Land at Climping, West Sussex

Transport Statement

i-Transport Ref: TW/BB/ITB16079-002D

Date: 22 March 2022

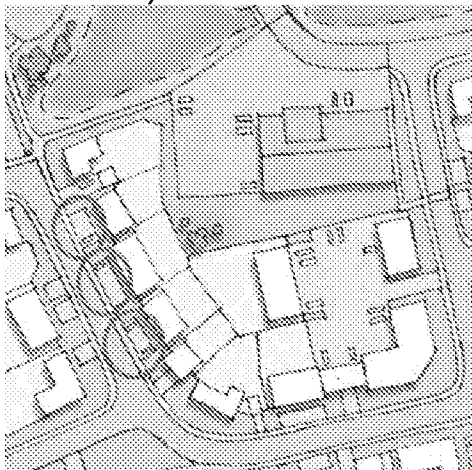
- *It should be confirmed if the road highlighted below has at least one footway abutting the carriageway unless there is a specific planning requirement/feature which requires a verge between the carriageway and footway.*

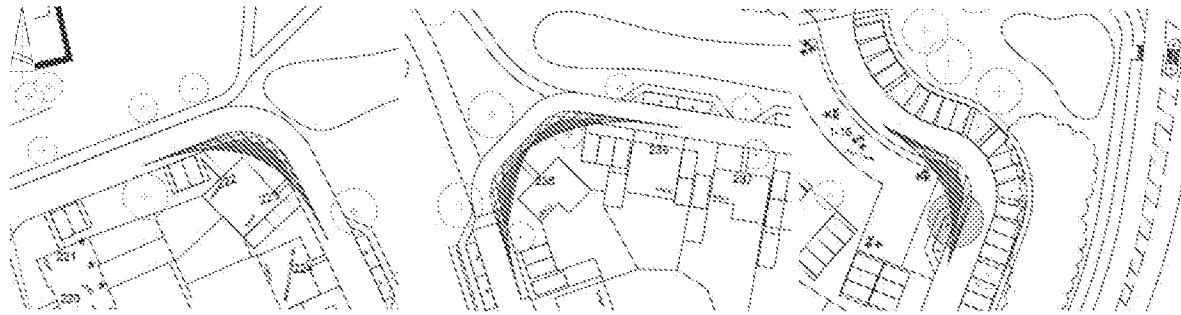
DESIGN ORGANISATION RESPONSE provided by i-Transport on the 15 th March 2022 following formal issue of this Stage 1 Road Safety Audit on the 14 th March 2022	
Agreed -- a covenant will be placed on the affected properties requiring that any planting must be maintained below 600m to ensure the visibility envelopes can be achieved.	
AUDITOR'S VIEW OF DESIGN ORGANISATION RESPONSE dated 15th March 2022	
Confirmation that visibility will be maintained clear of obstructions, addresses the road safety concern at this stage.	
A.2	GENERAL
	No Road Safety Concerns in GENERAL have been raised at this stage
A.3	JUNCTIONS
A.3.1	PROBLEM
Location:	Scheme
Summary:	Visibility extends across land outside the proposed highway
Acc Type:	Vehicle side impact collisions
The proposals associated with this Stage 1 Road Safety Audit, includes general carriageways with footways as well as shared surface areas that are to be provided within a residential development of 300 dwellings that each accommodate off-street parking, be it within driveways or parking courts. The scheme drawings provided with the Audit Brief, illustrate that 25 metre visibility splays are achievable where carriageways meet in accordance with the stopping sight distance of approaching vehicles travelling at 20mph. The presence of speed control bends and traffic calming measures in the form of raised tables and shared surface areas should ensure vehicular speeds are maintained low and that the achievable visibility is adequate. However, the visibility splays illustrated at many of the driveways and entrances to the parking courts, to include in proximity to the local shops and nursery, pass over land that is assumed to be outside the public highway. Should vegetation be planted and permitted to grow within the areas, visibility to and from approaching vehicles could be limited which may lead to a vehicle attempting to exit a priority access when it is not safe to do so, into the path of an oncoming vehicle and lead to side impact collisions.

RECOMMENDATION:	
It is recommended that a sufficient level of visibility is achievable at all times	
Location Plan: (NB: The image below highlights three locations where this item is relevant, more are be present)

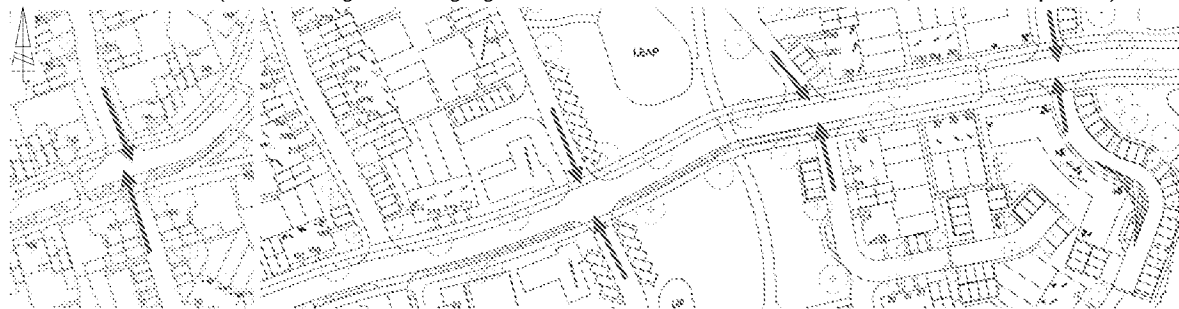
DESIGN ORGANISATION RESPONSE provided by i-Transport on the 15 th March 2022 following formal issue of this Stage 1 Road Safety Audit on the 14 th March 2022	
Agreed – A covenant will be placed on the affected properties requiring that any planting must be maintained to 600mm or below to ensure that visibility splays can be achieved.	
AUDITOR'S VIEW OF DESIGN ORGANISATION RESPONSE dated 15th March 2022	
Confirmation that visibility will be maintained clear of obstructions, addresses the road safety concern at this stage.	
A.3.2	PROBLEM
Location:	Scheme
Summary:	Priority may not be clear to drivers approaching junctions
Acc Type:	Vehicle side impact collisions
The proposals associated with this Stage 1 Road Safety Audit, includes general carriageways with footways as well as shared surface areas with a number of crossroad junctions generated. Vehicular speeds are expected to be low and priorities should be clear where surface treatments change, however, no such details have been provided at this stage and drivers will be able to see through the junction. There are concerns that traffic may approach the primary roads at inappropriate speeds and overshoot into the path of oncoming traffic or fail to give-way leading to side impact collisions

RECOMMENDATION:	
It is recommended that the point at which traffic must give-way is clear	
Location Plan: (NB: The image below highlights two locations where this item is relevant, more are to be present) 	
DESIGN ORGANISATION RESPONSE provided by i-Transport on the 15 th March 2022 following formal issue of this Stage 1 Road Safety Audit on the 14 th March 2022	
Agreed – Road markings will be provided at priority junctions with the primary roads and at the entrance to / exit from the parking facility associated with the proposed local shops.	
AUDITOR'S VIEW OF DESIGN ORGANISATION RESPONSE dated 15th March 2022	
Confirmation that road markings will be provided where appropriate, addresses the road safety concern at this stage.

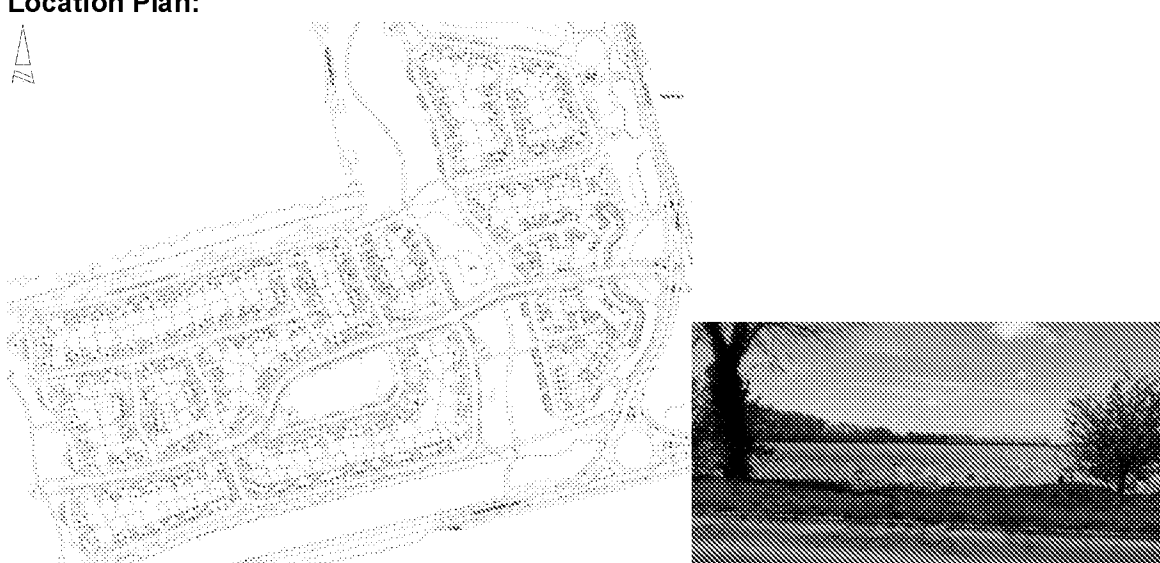
A.4	WALKING CYCLING AND HORSE RIDING
A.4.1	PROBLEM
Location:	Scheme
Summary:	Pedestrians may not be seen during the hours of darkness
Acc Type:	Vehicle pedestrian collision
The scheme drawing provided with the Audit Brief, illustrate that the proposed on-site highway is to consist of 4.8 and 6 metre wide carriageways as well as shared surface areas. At this stage, the Audit Team is unaware if the proposals are to be subject to street lighting. Whilst vehicles are driven during the hours of darkness with head lights illuminated, drivers may not become aware of the presence of pedestrians at a safe distance leading to vehicle pedestrian collisions.	
RECOMMENDATION:	
It is recommended that a level of street lighting is provided particularly in proximity to where pedestrians can be expected to cross or enter the carriageway and within the shared surface areas.	
Location Plan: 	
DESIGN ORGANISATION RESPONSE provided by i-Transport on the 15th March 2022 following formal issue of this Stage 1 Road Safety Audit on the 14th March 2022

Agreed - this will be dealt with at the detailed design stage.	
AUDITOR'S VIEW OF DESIGN ORGANISATION RESPONSE dated 15th March 2022	
Confirmation that this item will be considered during detail design, addresses the road safety concern raised at this stage.

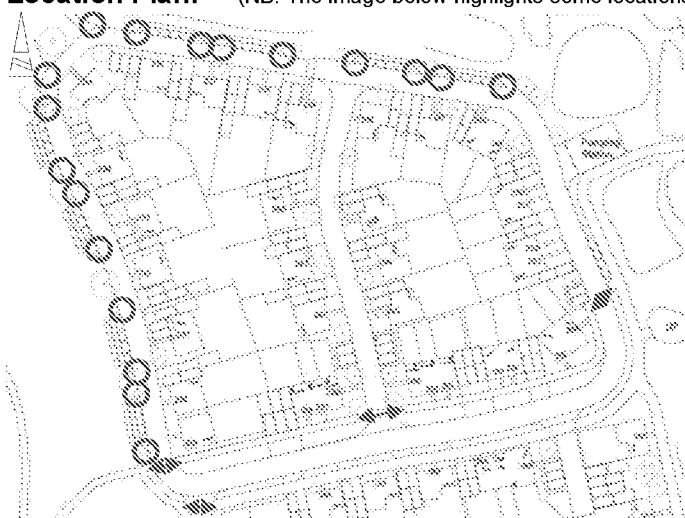
A.4.2	PROBLEM
Location:	Scheme
Summary:	Full height kerbs will be an obstruction to non-motorised users
Acc Type:	Trip / fall and personal injury, vehicle pedestrian collisions
The scheme drawing provided with the Audit Brief, identifies that the proposed development is to consist of general carriageways with footways as well as raised shared surface areas with direct accesses to pathways to properties and footpath / cyclepath links. At this stage no details have been provided to identify the proposed edge treatment around the shared surface areas. Kerbing in excess of 6mm is a trip hazard for pedestrians, those with perambulators, the mobility impaired and cyclists which could lead to falls and personal injury. Further, visually impaired pedestrians could enter a live carriageway into the path of a vehicle unaware leading to a vehicle pedestrian collision	
RECOMMENDATION:	
It is recommended that level access is provided with tactile paving where appropriate along non-motorised user desire lines.

Location Plan: (NB: The image below highlights some locations where this item is relevant, more are present) 	
DESIGN ORGANISATION RESPONSE provided by I-Transport on the 15th March 2022 following formal issue of this Stage 1 Road Safety Audit on the 14th March 2022	
Agreed - Desire lines will be assessed during the detail design of the scheme with dropped kerbs and tactile paving provided where necessary.	
AUDITOR'S VIEW OF DESIGN ORGANISATION RESPONSE dated 15th March 2022	
Confirmation that dropped kerbs and tactile paving will be provided, addresses the road safety concern raised at this stage.

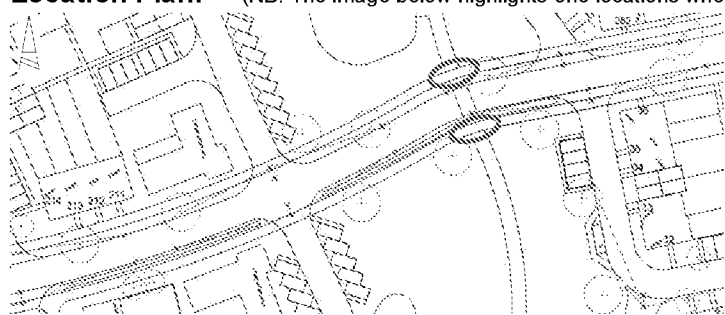
A.4.3	PROBLEM
Location:	Southern side of primary spine road
Summary:	No warning is provided to highlight the change in characteristics of the footways
Acc Type:	Vehicle pedestrian collisions
The proposals include the provision of numerous footways as well as shared surface areas and footpaths / cyclepaths through the open space within the application site. The Audit Team have concerns that pedestrians travelling from a footway will step onto a shared area without warning that cyclists or vehicular traffic could be present. A pedestrian not becoming aware that they are entering a shared area where cyclists or motorists could be present, may step into their path leading to a vehicle / cyclist collision with a pedestrian.	
RECOMMENDATION:	
It is recommended that corduroy / hazard warning tactile paving is provided where the characteristics of the surface change	
Location Plan: (NB: The image below highlights one locations where this item is relevant, more are present)

DESIGN ORGANISATION RESPONSE provided by I-Transport on the 15th March 2022 following formal issue of this Stage 1 Road Safety Audit on the 14th March 2022	
Agreed -- Corduroy paving will be provided where necessary, this will be dealt with at the detailed design stage.	
AUDITOR'S VIEW OF DESIGN ORGANISATION RESPONSE dated 15th March 2022	
Confirmation that tactile paving will be provided where appropriate, addresses the road safety concern raised at this stage.	
A.4.4	PROBLEM
Location:	Southern side of primary spine road
Summary:	Hedges could grow to limit visibility to and from a non-motorised user
Acc Type:	Vehicle pedestrian collisions
The proposals include the provision of numerous footpaths / cyclepaths through the proposed development area as well as footways besides the proposed on-site carriageways. The site layout plan provided with the Audit Brief, illustrates what is believed to be hedges to the south of the primary spine road and either side of where the proposed footpaths meet the carriageway. No landscaping details have been provided at this stage. Should the planting be permitted to grow higher than 600mm there is a risk that insufficient intervisibility will be available. Recent updates

to the Highway Code have introduced pedestrian and cyclist priorities over vehicular traffic and therefore drivers are required to stop and to allow non-motorised users to cross side roads, however, limited visibility could result to the users not becoming aware of one another at a safe distance leading to vehicle non-motorised user collisions	
RECOMMENDATION:	
It is recommended that no foliage is planted within pedestrian visibility slays to ensure clear visibility is maintained at all times	
Location Plan: (NB: The image below highlights two locations where this item is relevant, more are present) 	
DESIGN ORGANISATION RESPONSE provided by I-Transport on the 15 th March 2022 following formal issue of this Stage 1 Road Safety Audit on the 14 th March 2022	
Agreed – this will be dealt with at the detailed design stage.	
AUDITOR'S VIEW OF DESIGN ORGANISATION RESPONSE dated 15th March 2022	
Confirmation that this road safety concern will be further considered during the detail design of the scheme, addresses the road safety concern raised at this stage.
